Pimkie Apparels Ltd. (9205)

Plot #328, Bloc #F, Tongi Industrial Area, Tongi

27.May.2014

Identified Priority 1 Concerns

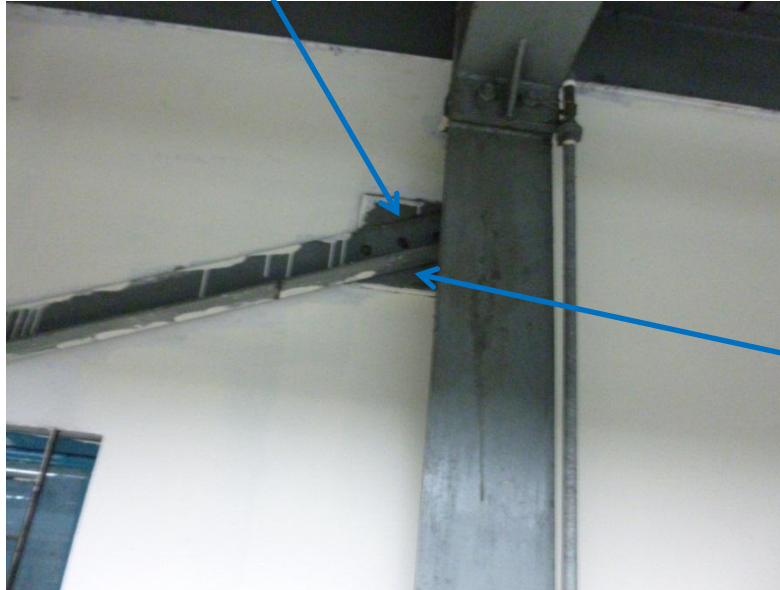
At the garments building, no fireproofing material was noted on structural steel elements as suggested by BNBC 2006.

2nd Priority 2 Concern

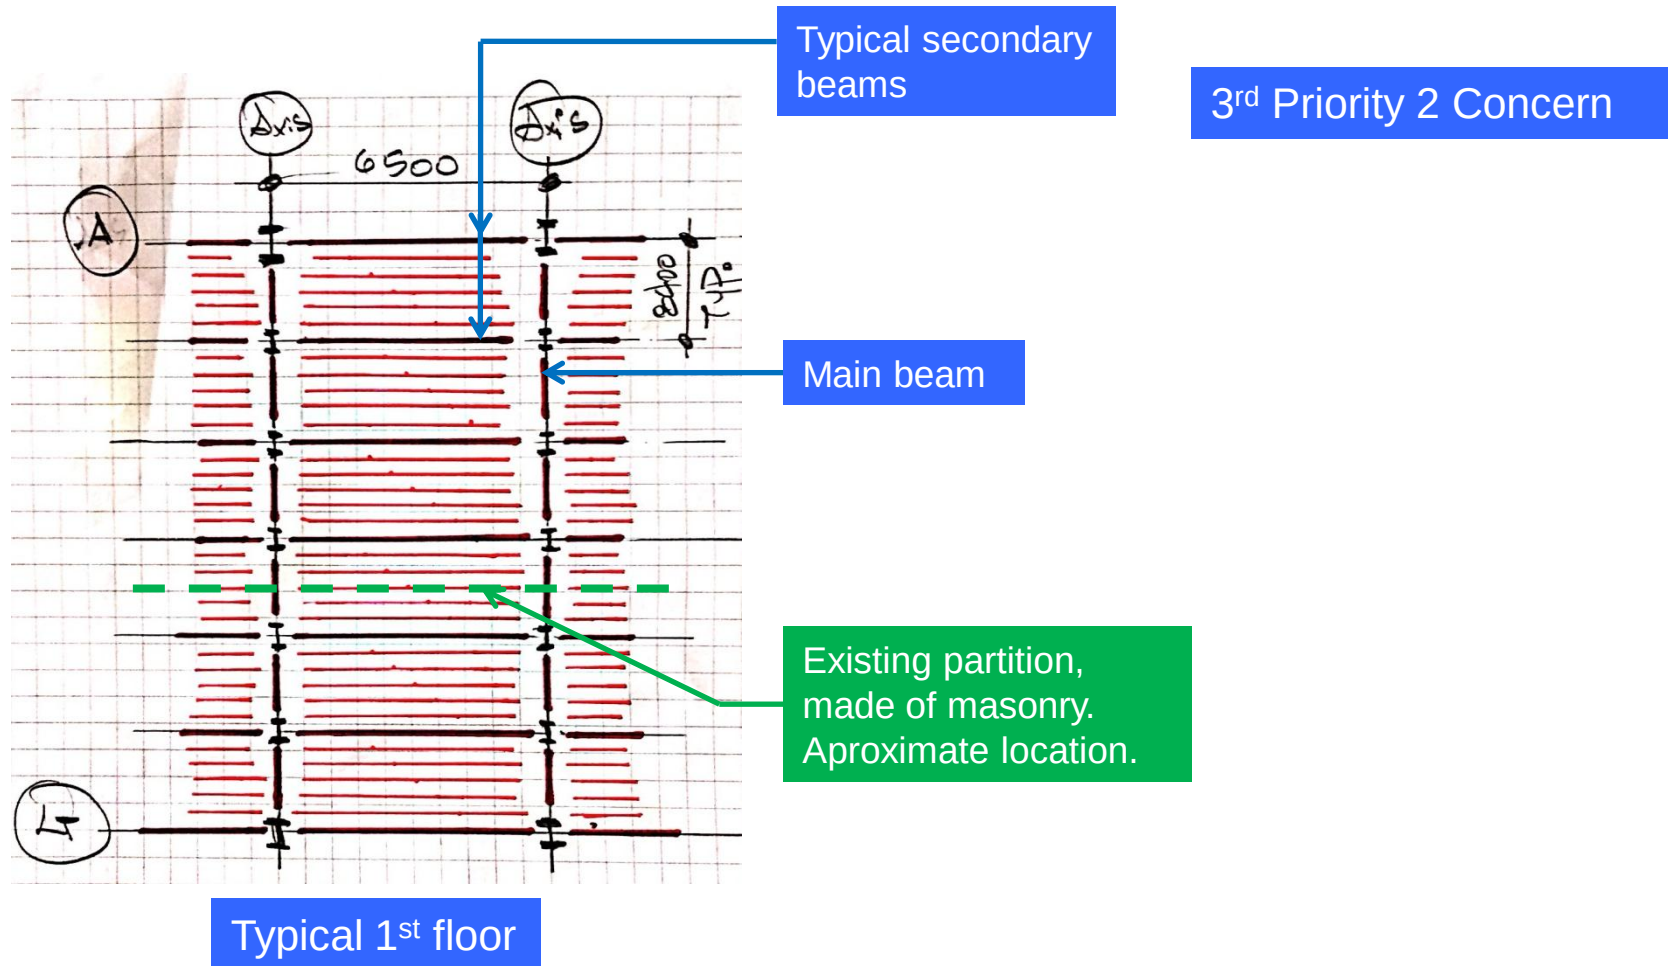
Existing welding
at the gosset plate

New welding
at the gosset plate

At the Garment Building all of the bracing (made of an angle L75x75) connexion is done by welding fixed to a gosset plate at the column. For the member used for the bracing, the angle has to be welded on both side at the gosset plate. Also the neutral axis of the bracing, column and perpendicular beam aren't converging at the same point. This means that all the connexion of those members are capable to receive some moments. A design check of all of the bracing connexion structural must be included in the Detailed Engineering Assessment.

1st Priority 3 Concern

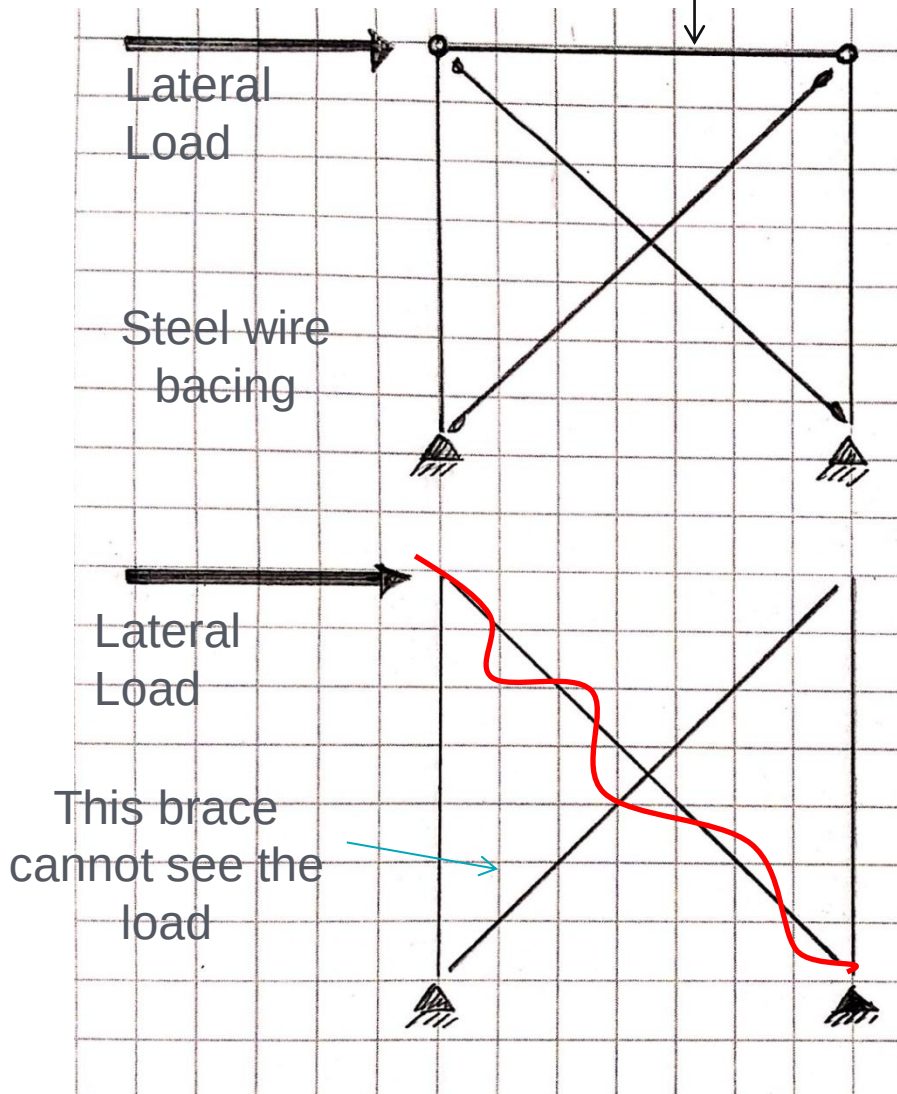
At the roof of the Generator Shed, the Fire pump Shed and the Boiler Shed all the steel roof must be verified for the uplift of these roofs including the bearing of these roofs made of brick walls. A design check of all of these sheds must be included in the Detailed Engineering Assessment.

Missing compression element

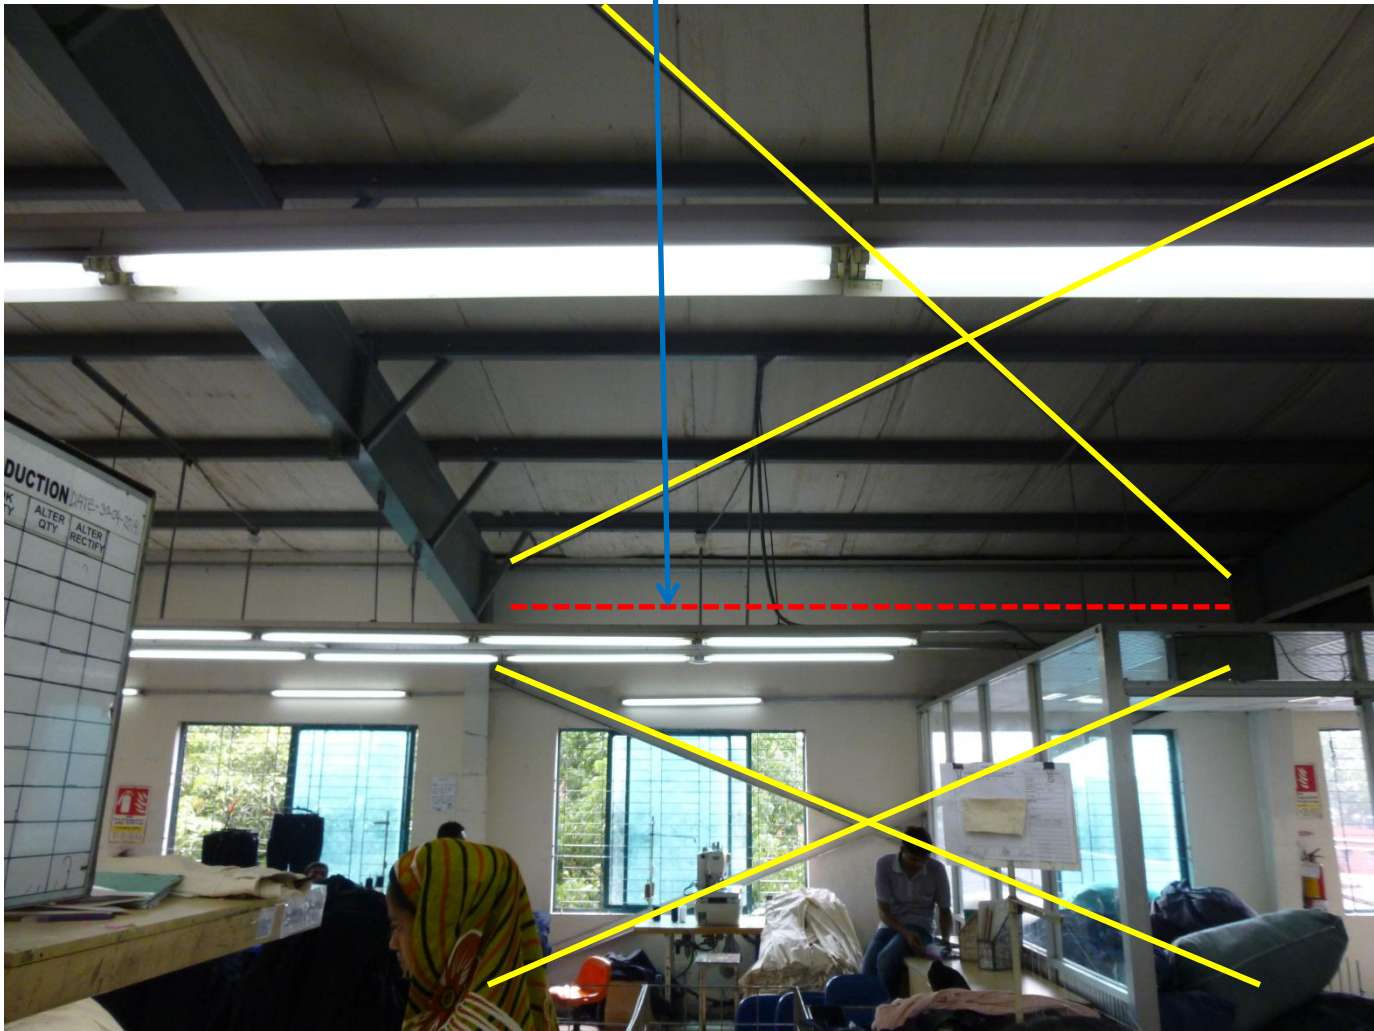
Where we have a concern is that at the end of the horizontal bracing, the vertical bracing does not always have the collecting element at the top (compression element).

We require that this item be investigated in a Detail Engineering Assessment
